Addendum #1
T25-01597 - Classroom Alterations at Beau Valley PS
Closing Date: Thursday, May 1, 2025 before 11:00 AM

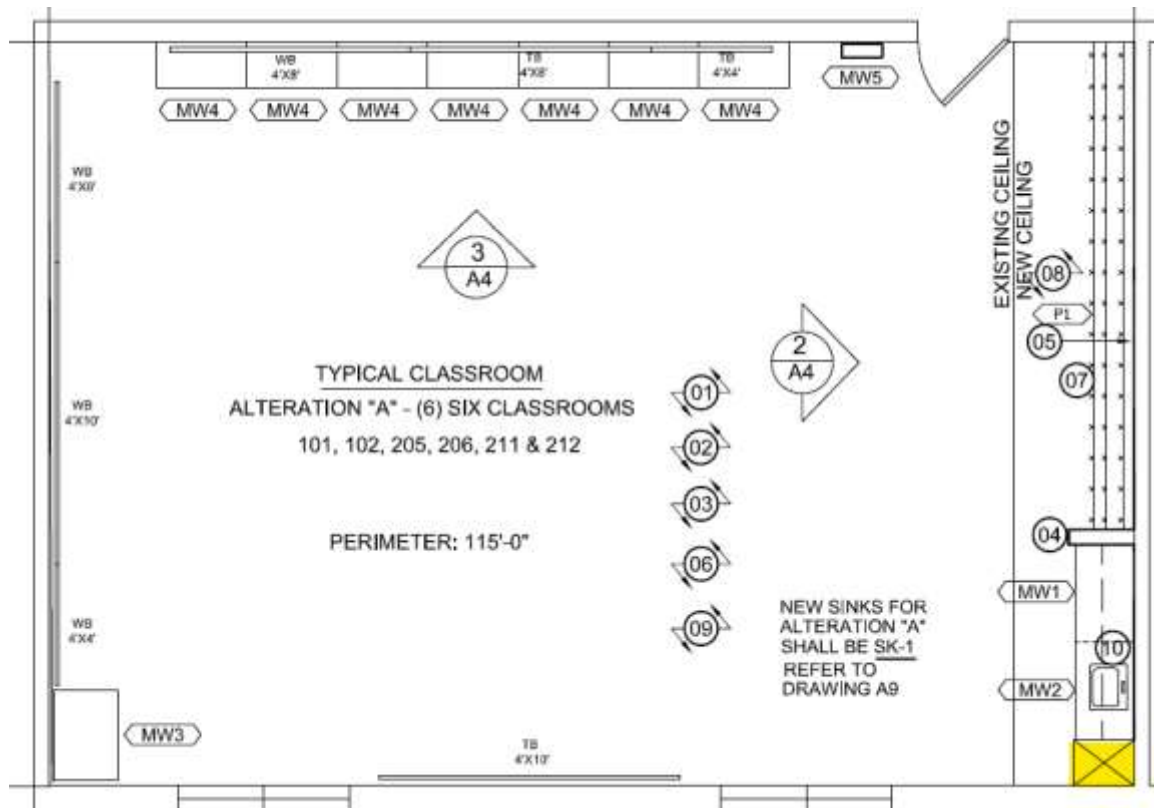
For the cash allowance, can you please confirm which materials are asbestos and/or lead containing in our work areas (Drywall Compound, VCT, Mastic, Boards, Adhesive, Caulking and Paint) so we know where not to include for applicable removals and disposals.

For demolition purposes the asbestos containing drywall compound is in the typical six (6) classrooms at the pipe chase locations shown in yellow. The classroom floor in the music room 209 is asbestos containing. Removal of these area's will be carried under the project cash allowance.
